February 28, 2019

Project No. 30401358

**RE: MONTHLY STATUS UPDATE – SOIL CAP AND CONCRETE CAP REPAIRS
RESPONSE TO REQUEST FOR INFORMATION – TCEQ LETTER DATED FEBRUARY 6, 2019
UNION PACIFIC RAILROAD HOUSTON WOOD PRESERVING WORKS FACILITY
4910 LIBERTY ROAD FACILITY, HOUSTON, TEXAS
POST-CLOSURE CARE PERMIT NO. HW-50343; INDUSTRIAL SWR NO. 31547**

TITLE
 PROPOSED SOIL BORING LOCATION MAP - TPH ANALYSIS

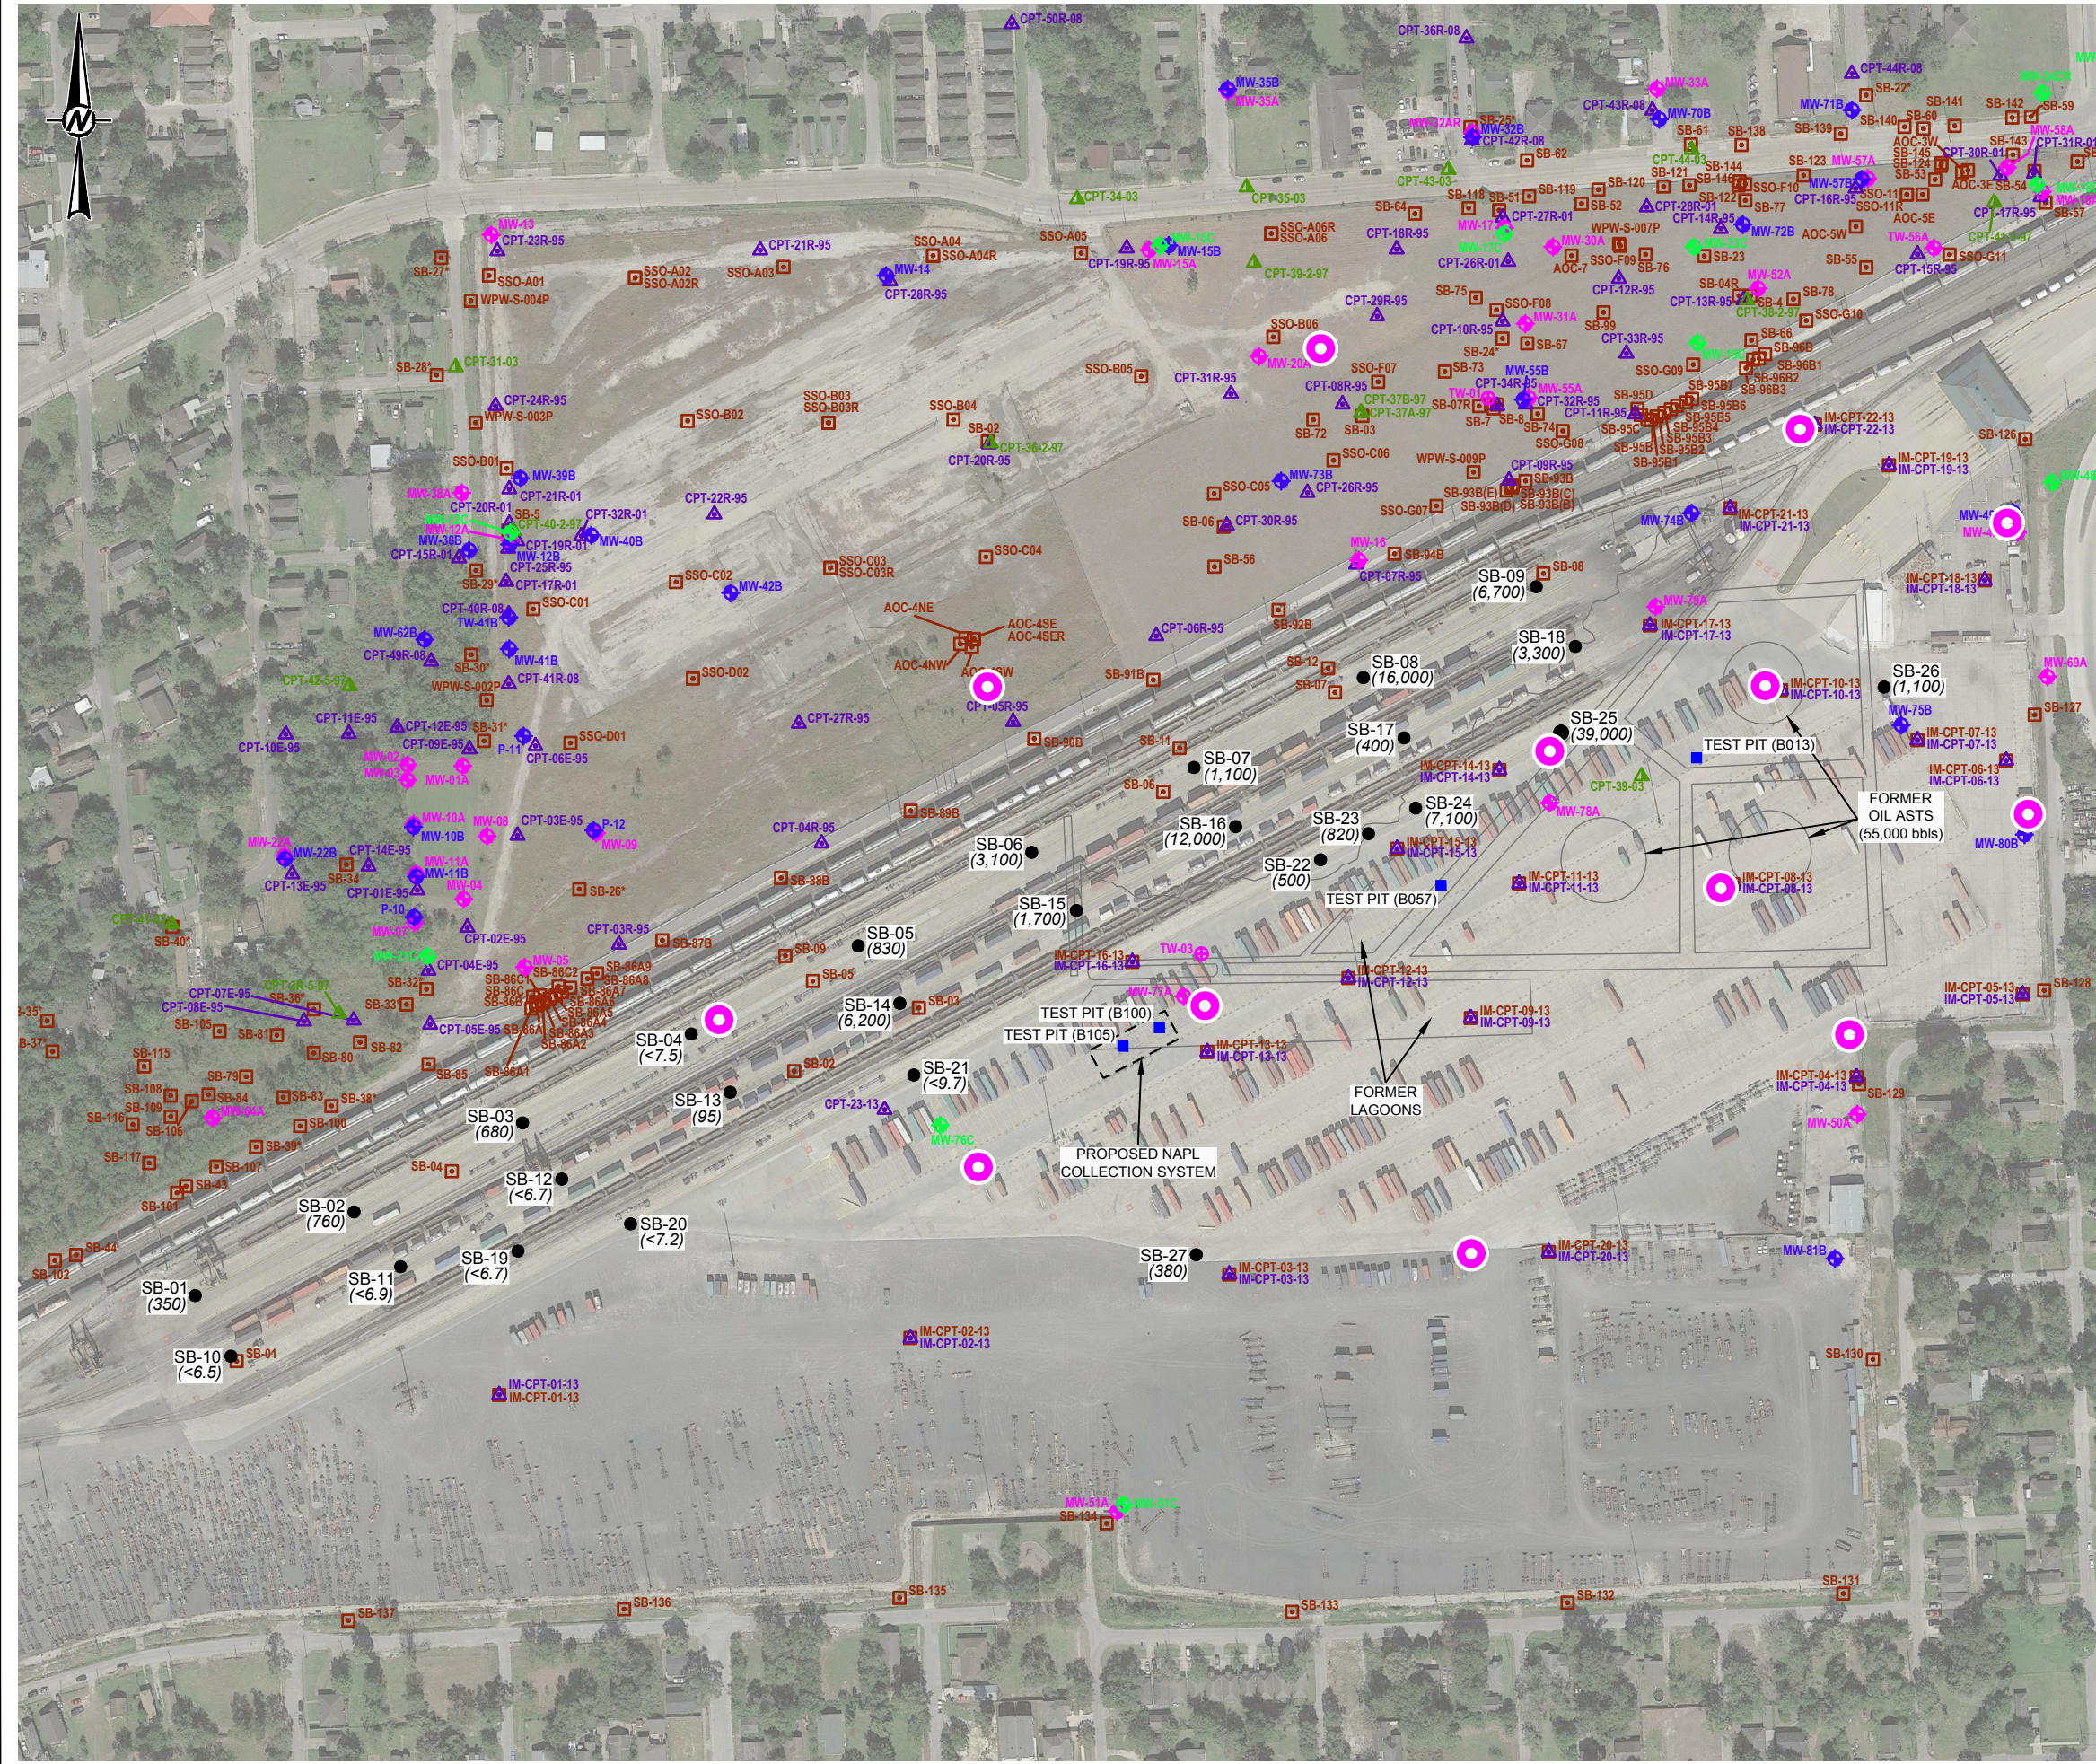
Additional horizontal assessment is needed to the north of soil sample locations SB-06 through SB-08, east of SB-09, SB-18, SB-25 and south of the four (4) TPH Non-aqueous Phase liquid (NAPL) test pits. Additional samples are needed in the vicinity of former two lagoons and three former 55,000-barrel above ground storage tanks (AST) since UPRR describes these units as potential source areas.

The TCEQ also notes, UPRR did not adequately delineate affected soils vertically pursuant to 30 TAC § 350.51(d) which requires the vertical extent of affected soils be delineated to the higher of the method quantitation limit (MQL) or background. Review of the TCEQ Method TX1005 results indicates many of the affected soils have TPH concentrations exceeding the Tier 1 soil-to groundwater (^{GW}Soil_{ing}) PCLs. UPRR's CPT/ROST NAPL assessment is useful information in identifying the presence of subsurface NAPL, but the assessment does not identify if affected subsurface soils have impacted groundwater.

To address the horizontal and vertical assessment for TPH concentrations in soils, UPRR proposes to drill and sample 13 soil boring locations, of which 9 borings will be located encircling the former lagoon and AST area and 4 will be drilled within the former lagoons and AST area. The proposed sample locations are presented on the attached Figure 1. Soil borings will be drilled to the top of the A-TZ (assumed to be approximately 15 feet below ground surface (bgs)). Soil samples will be collected continuously for the total depth of each boring and logged by

field personnel and field screened using an organic vapor meter (OVM). At each boring location, up to two soil samples will be submitted for laboratory analyses for TPH by Method TX1005. Soil samples will be collected from the following intervals:

- A soil sample from the 0 to 5-foot interval (Surface Soil) where the highest OVM reading or visual hydrocarbon staining is observed; or, if no OVM readings or staining observed, a sample from the 2 to 5-foot interval will be collected (below the existing asphalt/concrete); and
- A soil sample from a depth below 5 feet to 15 feet (Subsurface Soil) where the highest OVM reading or visual hydrocarbon staining is observed; or, if no OVM readings or staining observed, a sample from 13-15 feet interval (typically the top of A-TZ).
